Service Bulletin

REF: JD 26/93

XJ6 AND XJ12 1994 MY ALL VARIANTS

00 INFORMATION ADDITIONAL TO THE 94 MY TECHNICAL GUIDE

FIG. 1

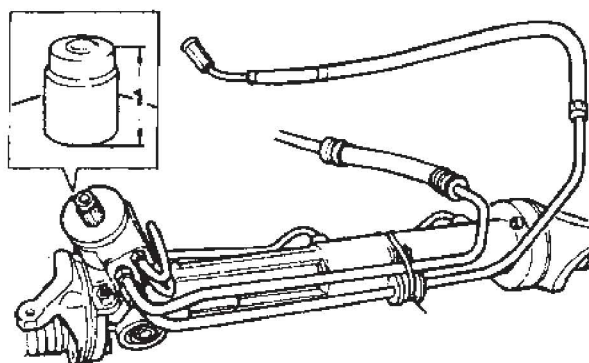
INTRODUCTION OF THE ZF PHASE 2 STEERING RACK

The ZF Phase 2 Steering Rack (Fig. 1) is added to the 1994 MY specification. The rack body consists of two aluminium pressure diecastings; the rack mounting is unchanged. The pinion height (1, Fig. 1) is increased by 7mm; the steering column is altered to accommodate this change. The fluid pipe union positions in the valve block are also altered, with the fluid pipes being modified accordingly. The steering rack assembly is a non-serviceable item.

FIG. 2

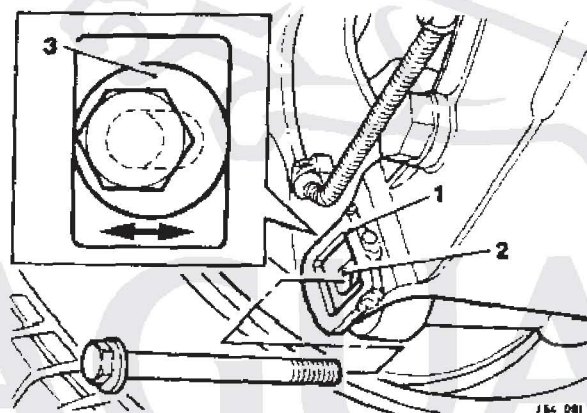
INTRODUCTION OF REAR WHEEL ALIGNMENT ADJUSTMENT

A system of rear wheel alignment adjustment is now incorporated in the rear suspension assembly.

The lower suspension arm has a plate, with a rectangular recess machined in the centre, added to the rear pivot eye (1, Fig. 2). The suspension arm pivot bolt hole (2, Fig. 2) is elongated, horizontally, at this point.

The pivot bolt has an integral eccentric (3, Fig. 2) below the bolt head, which, when in position in the plate, has a slight clearance at the sides but full clearance at the top and bottom. Rotation of the bolt head, with the eccentric constrained between the vertical faces, causes the bolt shank to be moved in the horizontal plane, thus displacing the hub carrier and effecting wheel alignment adjustment.

Fig. 1

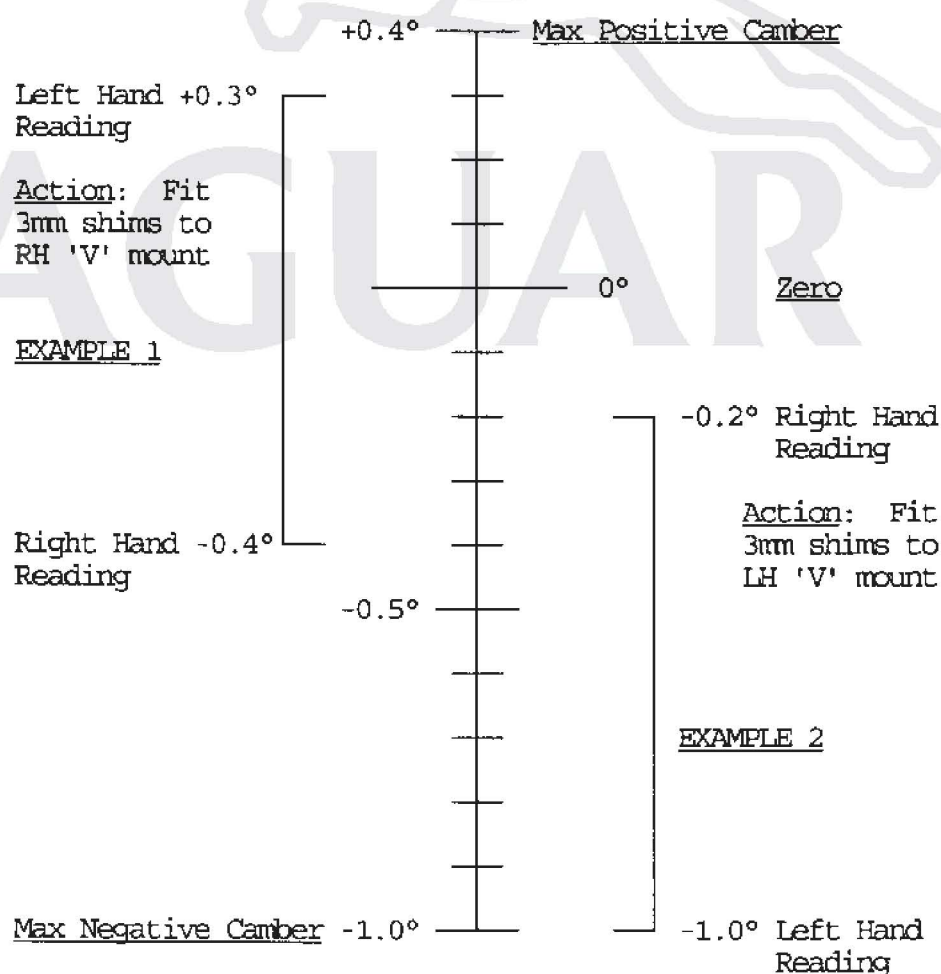
3. Calculate the camber imbalance by subtracting the lower or negative figure from the higher figure obtained.

See Fig. 1 below.

4. ADD shims to the side of the vehicle on which the GREATER NEGATIVE or SMALLER POSITIVE reading was obtained.

The objective is to reduce the measured camber imbalance by fitting a MAXIMUM of 3 adjustment shims. Each shim added corrects 0.1° of camber imbalance.

Fig. 2.

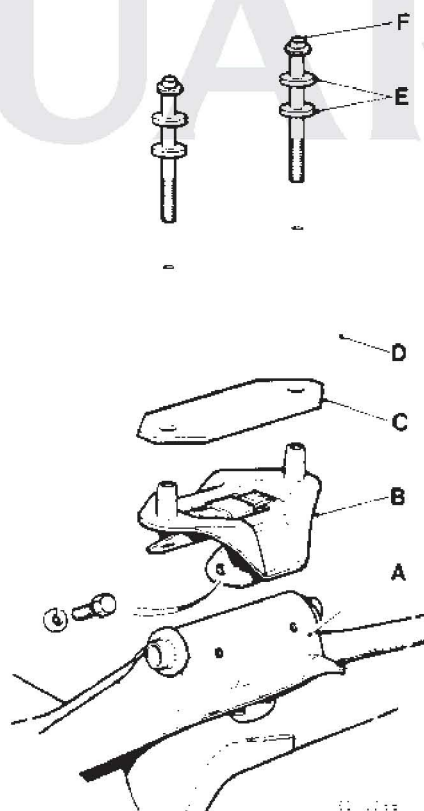
6. The Camber Angle Adjustment Shims (Item C, Fig. 2) are fitted between the crush tube (Item D) and the 'V' Mount (Item B), as indicated in Fig. 2.

IMPORTANT: WHERE SHIMS ARE FITTED, THE EXISTING BOLTS (ITEM F, Fig. 2) MUST BE REPLACED BY LONGER BOLTS, PART NO. JZB 100057, TOGETHER WITH 2 WASHERS, PART NO. C 21069 (ITEM E, Fig. 2) FITTED BETWEEN THE HEAD OF EACH BOLT AND THE UPPER FACE OF THE CRUSH TUBE.
